UNITED STATES PATENT AND TRADEMARK OFFICE

APPLICATION NO.	FILING DATE	FIRST NAMED INVENTOR	ATTORNEY DOCKET NO.	CONFIRMATION NO.
10/807,213	03/22/2004	Chun Ta Lee		3301
25859 7590 03/20/2007 WEI TE CHUNG FOXCONN INTERNATIONAL, INC. 1650 MEMOREX DRIVE SANTA CLARA, CA 95050			EXAMINER FIGUEROA, FELIX O	
			ART UNIT	PAPER NUMBER
			2833	
SHORTENED STATUTORY PERIOD OF RESPONSE		MAIL DATE	DELIVERY MODE	
3 MONTHS		03/20/2007	PAPER

Office Action Summary

DETAILED ACTION

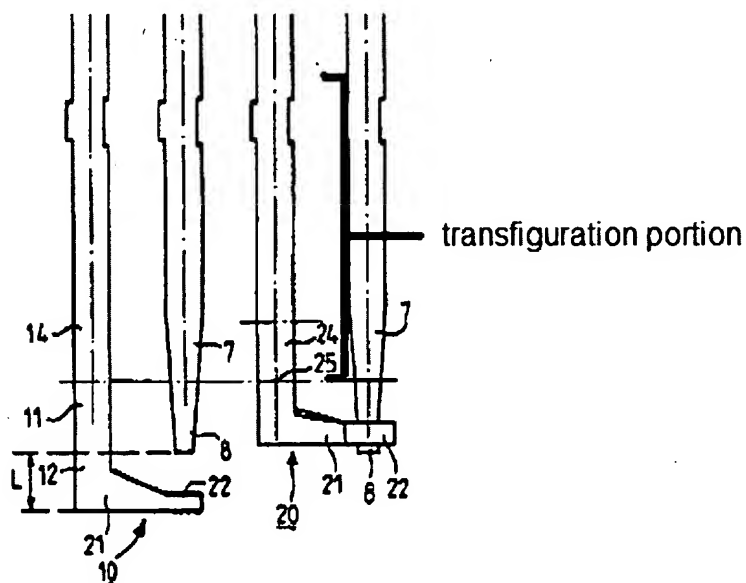
Pernet discloses a switching terminal assembly comprising: a carrier strip (2); a first terminal (5) extending from one edge of the carrier strip and defining a main plane

and having an elongate, a first base section (adjacent carrier 2) with thereof a first retaining [section] at a root region and a first contact section (at 8) at a tip region; a second terminal (4) for electrically connecting with the first terminal, extending from the edge substantially parallel to the first terminal from an elevational view, the second terminal including a second retaining section at thereof a root region, the second retaining section being coplanar with the first retaining section, an elongated second transfiguration (between 2 and 11) section connected to the second retaining section, an angled portion (at 11) connected to the second transfiguration section, and a pressing portion (at 22) connected to the angled portion; wherein a tip section (22) of the pressing portion is essentially located at a same level with the first contact section (vertical level in Fig. 2a), and the pressing portion is offset from the main plane from a side view.

Pernet discloses substantially the claimed invention except for the second contact section instead of the first contact section extending transversely to the longitudinal direction. It would have been obvious to one having ordinary skill in the art at the time the invention was made to form the first contact section extending transversely to the longitudinal direction to simplify the construction of the second terminal, and since it has been held that rearranging parts of an invention involves only routine skill in the art. *In re Japikse*, 86 USPQ 70.
